Minutes  
for  
**90<sup>th</sup> PCC Meeting**

**Date: 13.05.2020**  
**Eastern Regional Power Committee**  
**14, Golf Club Road, Tollygunge**  
**Kolkata: 700 033**

## AGENDA FOR 90<sup>TH</sup> PROTECTION SUB-COMMITTEE MEETING TO BE HELD ON 13.05.2020 AT 10:00 HOURS

#### ITEM NO. B.1: Tripping of both running units at 220 k V TTPS on 15.03.2020 at 16:12 hrs.

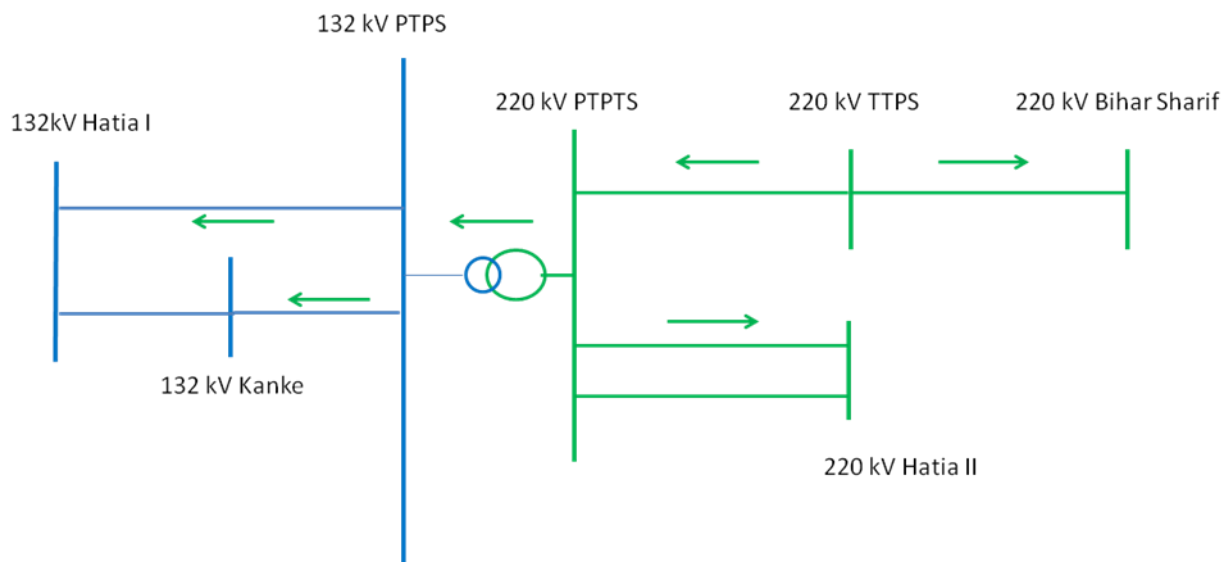
Jharkhand SLDC/JUSNL is advised to share the reason for tripping of 220 kV PTPS – TTPS S/C at PTPS end to ERLDC/ERPC. Also, the reason for non-triggering of any DR at PTPS end needs to be Name Relay Indication at End 1 Relay Indication at End 2 220 kV TTPS – PTPS S/C Did not trip Relay indication yet to be received; Detail report for this GD event at JUSNL system is yet to be received from Jharkhand SLDC

BSPTCL is requested to review O/C protection setting at Biharshariff end.

JUSNL explained that there was no physical fault in 220kV and 132 kV system at PTPS but voltage dip was observed for 300 ms at PTPS S/s. JUSNL informed that 220 kV TTPS – PTPS S/C line tripped from PTPS end on zone 4 within 100 ms. JUSNL added that as per DR bus voltage became almost zero and relay sensed as zone 4 fault.

ERLDC informed that after tripping of 220 kV TTPS – PTPS S/C line, 220 kV TTPS – Biharshariff S/C line got tripped from Biharshariff end on backup overcurrent protection. ERLDC observed that Biharshariff end has conservative setting.

After detailed analysis PCC opined that there might be a fault in downstream network of Patratu PTPS S/s and the fault was not cleared by 132kV Protection system at Patratu PTPS.

BSPTCL informed that the backup overcurrent settings has been revised from 600 A to 900 A after disturbance.

PCC advised JUSNL to take the following measures to avoid the unwanted tripping of transmission lines:

- Check any fault was appeared in downstream network of Patratu PTPS S/s
- Send the relevant DR of zone 4 tripping of 220 kV TTPS – PTPS S/C line at PTPS end
- Check the zone 4 reach and time settings of 220 kV TTPS – PTPS S/C line at PTPS end as the line should not trip within 100 ms.
- Test the protection relays of 132kV and 220 kV system at PTPS including 220/132kV ATRs

### **ITEM NO. B.2: Black out at 220 k V Tenughat Substation on 14.04.2020 at 12:47 hrs.**

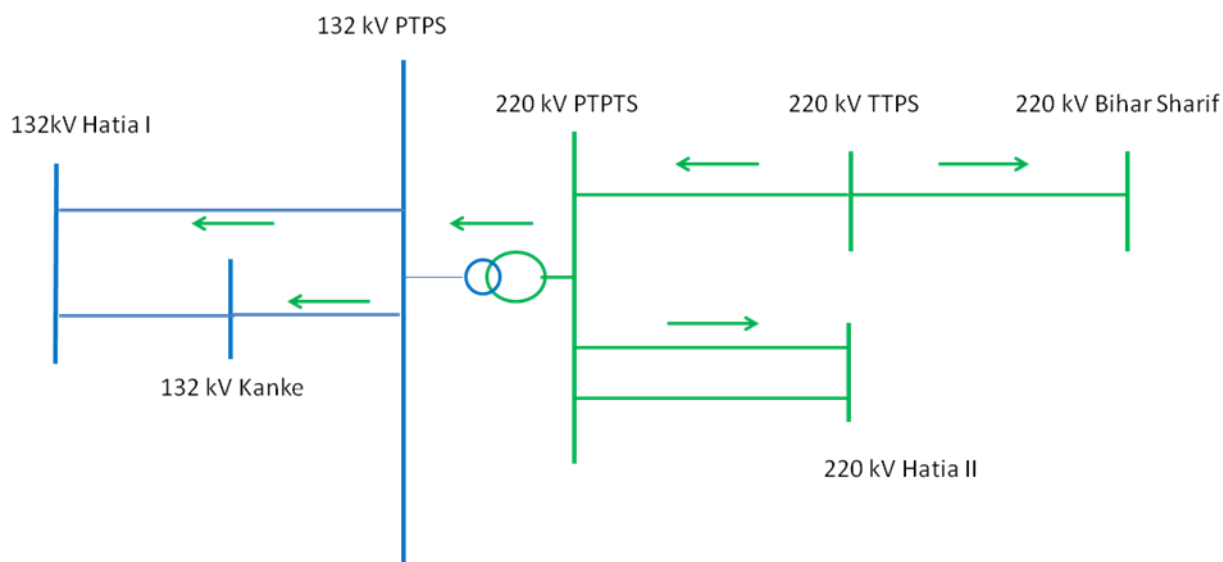
BSPTCL informed that at 12:32 hrs, there was a high resistive B-N fault in 220 kV TTPS – Biharshariff S/C line at 58 km from Biharshariff end. Biharshariff end cleared the fault in zone 1 distance protection and TVNL end got tripped on directional E/F protection. Delayed tripping was observed at TVNL end due to high pickup value of E/F protection settings.

JUSNL informed that at 12:46 hrs, 220 kV TTPS – PTPS S/C tripped from PTPS end on Earth Fault protection. JUSNL failed submit the DR for the tripping. There was no tripping from TTPS end.

After detailed deliberation. PCC opined that tripping of 220 kV TTPS – PTPS S/C line not clear, PCC advised JUSNL to collect the details and submit to ERPC and ERLDC.

PCC advised BSPTCL, JUSNL and TVNL to take following corrective measures to avoid frequent tripping of the lines:

- 220 kV Tenughat Biharshariff S/C tripped 7 times in the months of March and April, 2020. 220 KV TTPS PTPS line also tripped several times in March and April 2020. JUSNL and BSPTCL were advised to carry out the line patrolling and ensure healthiness of these line.
- TVNL was advised to review the O/C, E/F protection settings of 220 kV Tenughat Biharshariff S/C , O/C , E/F protection settings of PTPS unit so that high resistance faults could be identified reliably.

**ITEM NO. B.5: Disturbance at 220 k V Chandil Substation on 29.03.2020 at 19:21 hrs.**

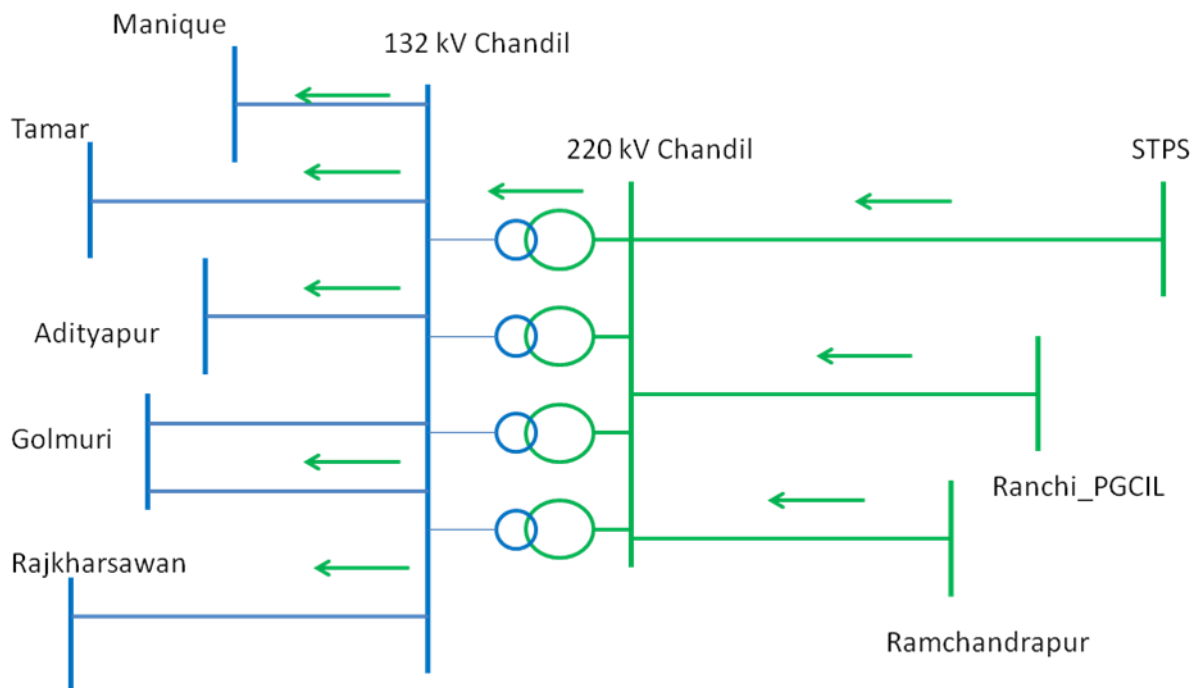
As per PMU and DR data, fault was cleared after 1.2 sec.

Make, year of installation, year of manufacturing and last inspection report of failed CT may be shared with ERPC/ERLDC by the utility as discussed in 89th ER PCC meeting.

JUSNL/WBPDCL may explain reason for not receipt of carrier signal at STPS end in spite of sensing the fault in zone 1 at Chandil end

JUSNL may share the status of installation of bus bar protection at Chandil.

After detailed analysis by the PCC forum, the following points were observed:

- At 19:21 hrs, R-N fault occurred at 220kV bus of 220/132kV Chandil S/s due to failure of R phase CT of 220 kV STPS bay
- 220 kV Chandil -STPS S/C line tripped from STPS end within 350 ms on zone 2

- 220 kV Chandil- Ranchi S/C line tripped from Ranchi end within 350 ms on zone 2
- 220kV Chandil-Ramchandrapur S/C line got tripped within 100 ms. (Relay fault pickup details are not available due to incorrect DR configuration).

- For all the above lines Chandil end relay observed the fault in zone 4.
- 132kV Chandil-Adityapur and 132kV Chandil-Rajkaswan line protection relays (back over current E/F protection) identified the fault

- In the mean time after 0.5 sec, Y-N fault appeared at 220/132kV Chandil S/s
- Both the faults finally got cleared from 132kV line protection system at Adityapur and Rajkaswan after 1.1 sec

- Details of other 132kV source, 132kV Chandil-Golmuri line is not available.
- It was observed that 220/132kV ATRs failed to clear the fault in time as a result 132kV lines got tripped.

- Total fault clearing time is around 1.2 seconds as per PMU data.

PCC observed the following discrepancies and advised JUSNL and WBPDCCL to take appropriate action:

- 220kV Chandil-Ramchandrapur S/C line got tripped within 100 ms. (Relay fault pickup details are not available due to incorrect DR configuration) JUSNL may check timing of distance protection at Ramchandrapur.

- Disturbance recorders of all the substations of JUSNL involved in this disturbance are to be configured as per the ERPC guidelines.
- STPS end DR of 220kV Chandil-STPS line is to be configured as per the ERPC guidelines

- Protection system of 220/132kV ATRs to be tested and the settings are to be coordinated with 220kV and 132 kV protection relays.
- Busbar protection for all 220kV substations are to be installed to minimize the fault clearing time.

- As 220kV Chandil S/s has single bus and transfer scheme, option for sectionalizer may be explored.
- Healthiness of carrier signal of 220kV Chandil-STPS line is to be checked.

**ITEM NO. B.6: Total Power failure at 220 k V Chandil Substation on 15.04.2020 at 17:20 hrs.**

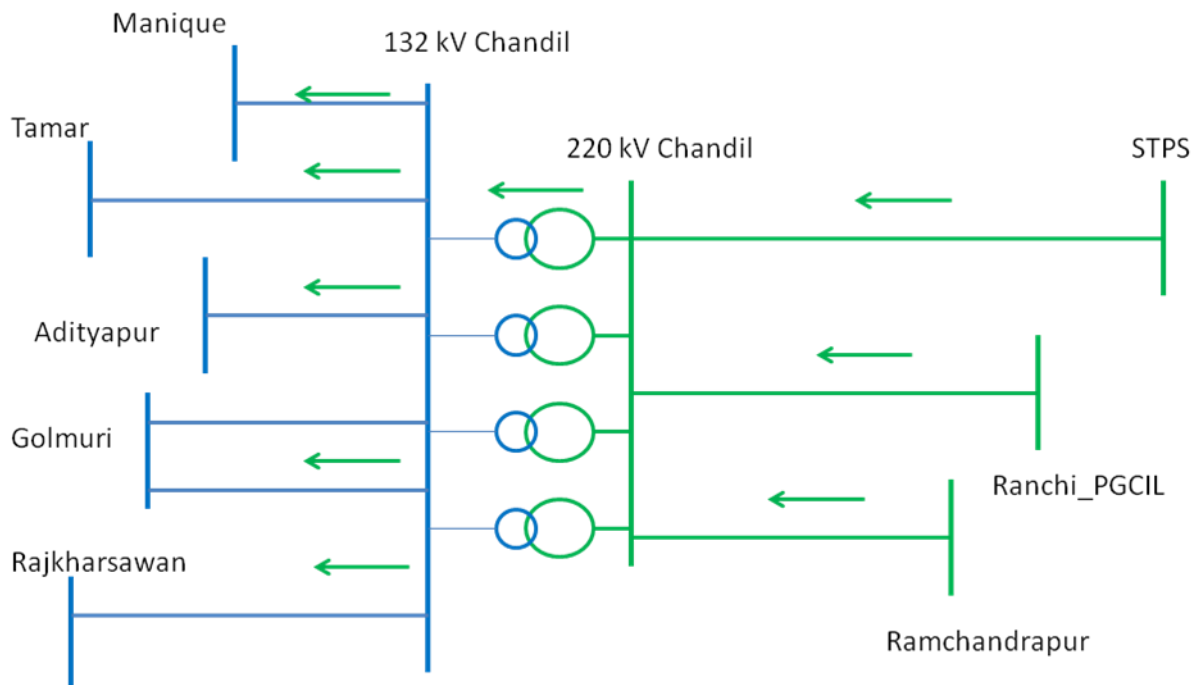
Reason and location of fault and how fault was cleared may be shared by JUSNL. Ranchi, and Ramchandrapur end relay indication and DR/EL (if triggered) may be shared by PGCIL ERTS - 1/JUSNL.

Santaldih TPS and Chandil end DR is to be time synchronized and all DRs recorded at Chandil end and DR recorded for Chandil feeder at STPS end may be configured as ER PCCs recommendation

Reason for opening of B phase CB at Chandil end of 220 kV STPS end feeder at 2500 ms (R and Y phase breaker opened at 500 ms after sensing the fault) after sensing the fault may be shared.

After detailed analysis by the PCC forum, the following points were observed:

- At 17:20 hrs, B-N fault occurred at 132kV bus of 220/132kV Chandil S/s, later the fault got converted into three-phase fault
- Since the fault was in 132kV system, there was no pickup by the remote end distance protection of 220kV lines. Only over current E/F pickup was observed at Ranchi end. Chandil end distance protection identified the fault in zone 4 for all 220kV lines and issued trip command to respective line breakers after 0.5 sec.
- CBs of Ramchandrapur and Ranchi 220kV lines got tripped but B-ph pole of 220kV STPS line CB failed to open.

- Thereafter, STPS end over current E/F protection identified the fault and got tripped from STPS end after 2 sec. Since the fault was in 132kV system the fault current observed at STPS end was less which resulted into longer time for clearing the fault.
- In the mean time, 132kV Chandil-Adityapur line, 132kV Chandil-Rajkaswan line and 132kV Chandil-Golmuri line got tripped by backup overcurrent E/F protection after 1.5 sec.
- It was observed that 220/132kV ATRs failed to clear the fault in time as a result 132kV lines got tripped.
- Total fault clearing time was around 4 sec

PCC observed the following discrepancies and advised JUSNL to take appropriate action:

- Disturbance recorders of all the substations involved in this disturbance are to be configured as per the ERPC guidelines.
- CB of 220kV STPS-Chandil line at Chandil end is to be tested
- Protection system of 220/132kV ATRs to be tested and the settings are to be coordinated with 220kV and 132 kV protection relays.
- Busbar protection for all 220kV substations are to be installed to minimize the fault clearing time.

**ITEM NO. B.7: Total Power failure at 220 k V Chandil Substation on 30.04.2020 at 19:37 hrs**

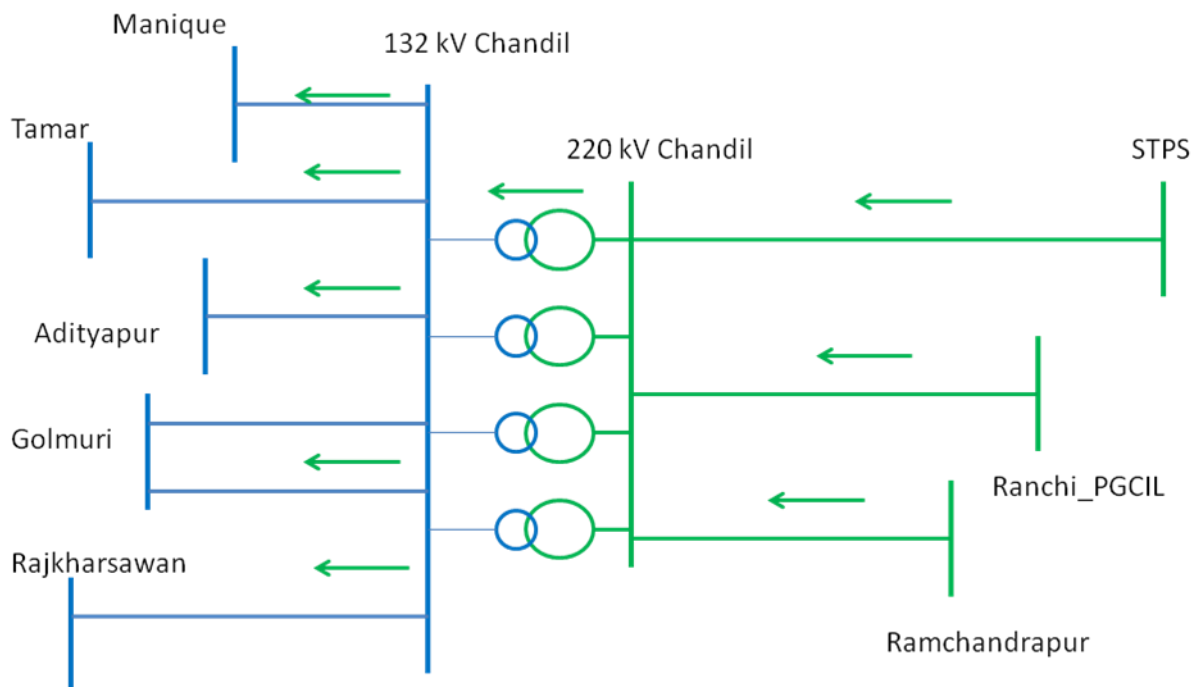
JUSNL may share the status of installation of bus bar protection at Chandil

Zone -4 setting of 220 kV Lines also need to be reviewed in coordination with 220/132 kV ICTs backup overcurrent protection setting

Reason for delayed fault clearance may be shared by JUSNL.

After detailed analysis by the PCC forum, the following points were observed:

- At 19:37 hrs, Y-N fault occurred at 132kV side of 100 MVA, 220/132kV ICT-3 at Chandil S/s.
- Since the fault was in 132kV system, there was no pickup by the remote end distance protection of 220kV lines. Chandil end distance protection identified the fault in zone 4 for 220kV Ranchi and Ramchandrapur lines and issued trip command to respective line breakers after 0.5 sec.

- Chandil end of 220kV STPS line failed to identify the fault in zone 4 initially and able to identified the fault in zone 4 after tripping of 220kV Ranchi and Ramchandrapur lines. 220kV Chnadil-STPS got tripped after 1.5 sec from the fault initiation.

- In the mean time, 132kV Chandil-Adityapur line, 132kV Chandil-Rajkaswan line and 132kV Chandil-Golmuri line got tripped by backup overcurrent E/F protection after 2 sec.

- It was observed that 220/132kV ATRs failed to clear the fault in time as a result 132kV lines got tripped.
- Total fault clearing time was around 2000 ms.

PCC observed the following discrepancies and advised JUSNL to take appropriate action:

- Disturbance recorders of all the substations involved in this disturbance are to be configured as per the ERPC guidelines.
- The reach and time settings of distance protection of 220kV STPS-Chandil line at Chandil end are to be reviewed.
- Protection system of 220/132kV ATRs to be tested and the settings are to be coordinated with 220kV and 132 kV protection relays.

**ITEM NO. B.8: Disturbance at 220 k V Muzaffarpur Substation on 28.03.2020 at 18:49 hrs.**

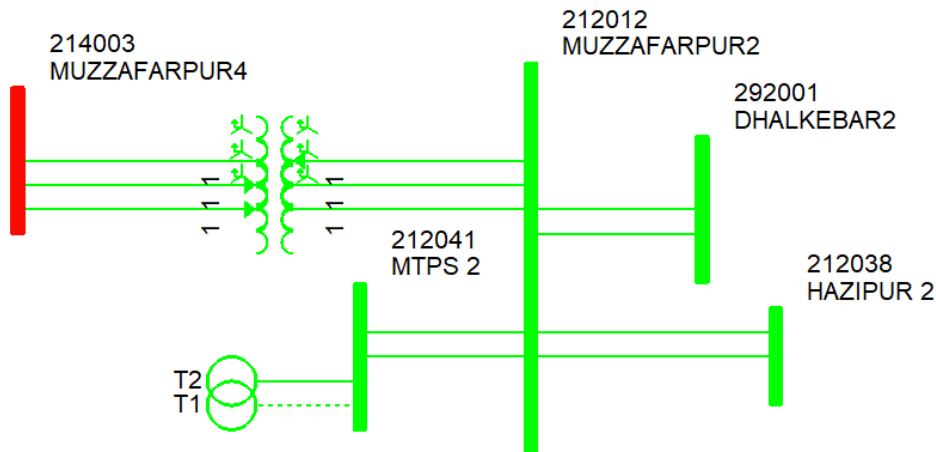
At 18:49 hrs, 220 KV Muzaffarpur bus 1 tripped on LBB maloperation associated with 400/220 KV ICT 1 CB. Due to this, 220 KV Muzaffarpur Hajipur 1, 220 KV Muzaffarpur KBUNL 2, 220 KV Muzaffarpur Dhalkebar - 1, 400/220 KV ICT 1 and 2 at Muzaffarpur tripped.

*Powergrid explained that due to malfunction of master trip relay at Muzaffarpur bus 1 tripped on LBB. Powergrid further added that faulty relay was replaced with new relay.*
